Access Compliance Report Public Rights-of-Way (Curb Ramps)

Intersection ID: 10021978Main Street:BROOKSVALE_STCross Street: N/ALocation:NWADA ID: 33F0B45C49BDRamp Type:PerpInitial Pass/Fail:FailOverall Compliance: NoSeverity Score:12.5

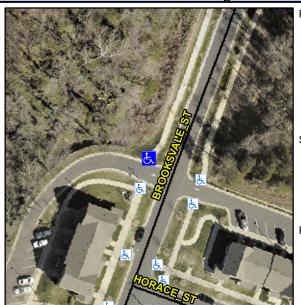
Field Measurements/Component Compliance						
Comp	liance Description	Data	Comp	liance Description	Data	
N/A	Ramp Length (in)	69.5	No	Ramp Slope (%)	9.9	
Yes	Ramp Width (in)	70.0	Yes	Ramp XSlope (%)	0.6	
N/A	Flare Type LT	N/A	N/A	Flare Type RT	N/A	
N/A	Flare Slope LT (%)	N/A	N/A	Flare Slope RT (%)	N/A	
N/A	Flare Traversable LT?	N/A	N/A	Flare Traversable RT?	N/A	
N/A	Landing Length (in)	N/A	N/A	DWS Provided?	N/A	
N/A	Landing Width (in)	N/A	N/A	DWS Contrast?	N/A	
N/A	Landing Slope (%)	N/A	N/A	DWS Length (in)	N/A	
N/A	Landing X Slope (%)	N/A	N/A	DWS Full Width?	N/A	
N/A	Landing Curb? (Y/N)	N/A	N/A	DWS Offset (in)	N/A	
N/A	Shared Landing?	N/A				
N/A	Gutter Ponding?	N/A	N/A	Gutter Slope (%)	N/A	
N/A	Gutter Lip Ht (in)	N/A	N/A	Gutter X Slope (%)	N/A	
N/A	Painted X Walk1?	No	N/A	Painted X Walk2?	N/A	
	X Walk 1 Direction	To SW		X Walk 2 Direction	N/A	
N/A	X Walk 1 Width (in)	N/A	N/A	X Walk 2 Width (in)	N/A	
	X Walk 1 Slope (%)	0.5		X Walk 2 Slope (%)	N/A

Possible Solutions:	Com
Remove & Replace Entire Ramp.	N/A
·	Yes
	N/A
	N/A
	N/A
	N/A
Surveyor Notes:	N/A
N/A	N/A
	N/A
	N/A
	N/A
PROW/ADA:	N/A
Not Found, R304.2.2	N/A
	N/A
	N/A
	N/A
